IBC - General

2024 GROUP A PROPOSED CHANGES TO THE I-CODES

Committee Action Hearings (CAH #2)
October 23 - 31, 2024
Long Beach Convention Center
Long Beach, CA

[BE] **SCISSOR STAIRWAY.** ~~Two interlocking~~ Independent stairways located within a common exit enclosure, providing not less than two separate paths of egress located within one *exit* enclosure.

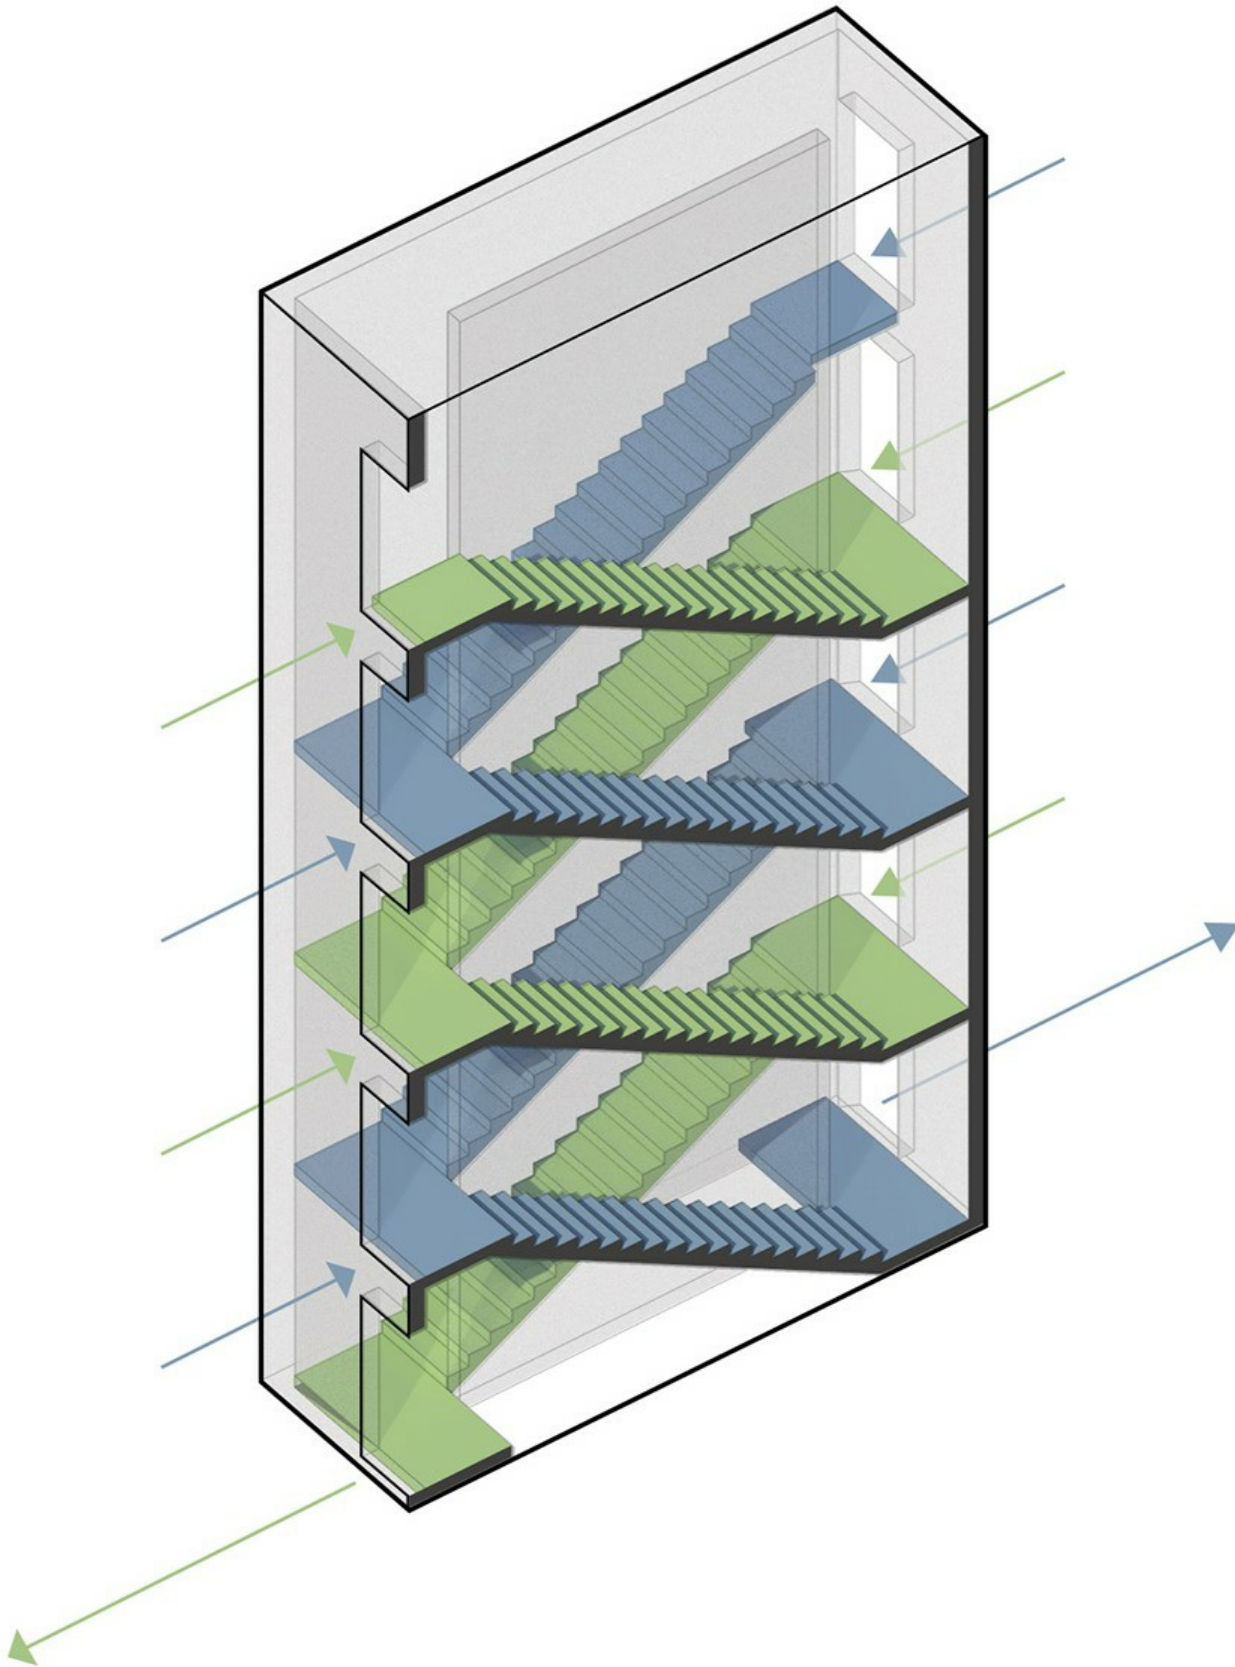
Reason: The term interlocking as defined in most dictionaries implies connection, and is defined as:

- Webster: 1. to lock together; join with one another. 2. to connect or be connected so that neither part can be operated independently.
- Merriam-Webster: 1. locked together. 2. to connect so that the motion or operation of any part is constrained by another.

A scissor stairway consists of separate stairways that are not connected. Each stairway serves the same function within a common enclosure, but they do so independently without constraining the other. Deleting the term interlocking and inserting independent offers a clearer description. The limit of “two” stairways is incorrect and must be deleted. Figure 1 shows an example of a scissor stairway with 8 stairways as the term stairway is defined in the IBC:
